# Product Support Bulletin 2007-008

**SUBJECT:** Installation of additional springs in the TRIPP Rail Lifter Pressure Reducing Valve – 3601520

**MACHINE MODEL(S):** TRIPP Tie Remover/Inserter

**SERIAL NUMBER(S):** 760125-760275

**Figure 1**  
Rail Lift Manifold  
(Viewed from Front of Machine)

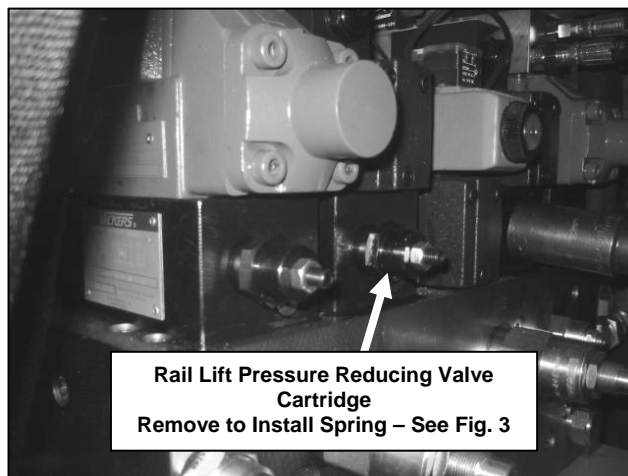
**SUMMARY:** On some machines, the Rail Lifter may rise unevenly to the Travel position. Installation of an additional spring in the Rail Lifter Pressure Reducing Valve will allow the valve to operate more consistently, reducing the tendency of the Rail Lifter to rise unevenly.

**OPERATIONAL IMPACT:** If the Rail Lifter rises unevenly, especially when it is being raised for travel, damage to the Rail Lifter LVDTs may occur. This causes the improper operation of the rail lifter during the work cycle.

**ACTION:** Both Pressure Reducing Valve Cartridges must be removed from the valve blocks and the new springs installed. The cartridges, along with both the original and the new springs are reinstalled into the valve block. See Figures 1, 2 and 3 on Page 2.
